Access Compliance Report

Public Rights-of-Way

(Curb Ramps)

Intersection ID: 10955	Main Street: ROBINSON_CHURCH_RD	Cross Street: BRAWLEY_LN	Location: NE
ADA ID: FC60E61A92E9	Ramp Type: Perp	Initial Pass/Fail: Fail	Overall Compliance: No
Severity Score: 46.25			
Codes/Mitigation Info/Possible Solution		Field Measurements/Component Compliance

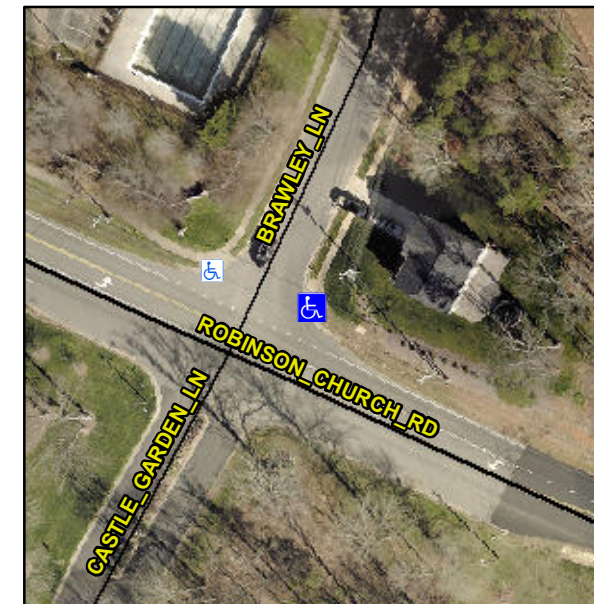
R304.5.1, R304.2.2, R304.5.3

Compliance	Description	Data	Compliance	Description	Data
N/A	Ramp Length (in)	48.5	No	Ramp Slope (%)	8.4
No	Ramp Width (in)	47.5	No	Ramp XSlope (%)	7.1
N/A	Flare Type LT	N/A	N/A	Flare Type RT	N/A
N/A	Flare Slope LT (%)	N/A	N/A	Flare Slope RT (%)	N/A
N/A	Flare Traversable LT?	N/A	N/A	Flare Traversable RT?	N/A
N/A	Landing Length (in)	N/A	N/A	DWS Provided?	N/A
N/A	Landing Width (in)	N/A	N/A	DWS Contrast?	N/A
N/A	Landing Slope (%)	N/A	N/A	DWS Length (in)	N/A
N/A	Landing X Slope (%)	N/A	N/A	DWS Full Width?	N/A
N/A	Landing Curb? (Y/N)	N/A	N/A	DWS Offset (in)	N/A
N/A	Shared Landing?	N/A			
N/A	Gutter Ponding?	N/A	N/A	Gutter Slope (%)	N/A
N/A	Gutter Lip Ht (in)	N/A	N/A	Gutter X Slope (%)	N/A
N/A	Painted X Walk1?	No	N/A	Painted X Walk2?	N/A
	X Walk 1 Direction	To NW		X Walk 2 Direction	N/A
N/A	X Walk 1 Width (in)	N/A	N/A	X Walk 2 Width (in)	N/A
	X Walk 1 Slope (%)	0.3		X Walk 2 Slope (%)	N/A
	X Walk 1 X Slope (%)	5.1		X Walk 2 X Slope (%)	N/A

Remove & Replace Entire Ramp.
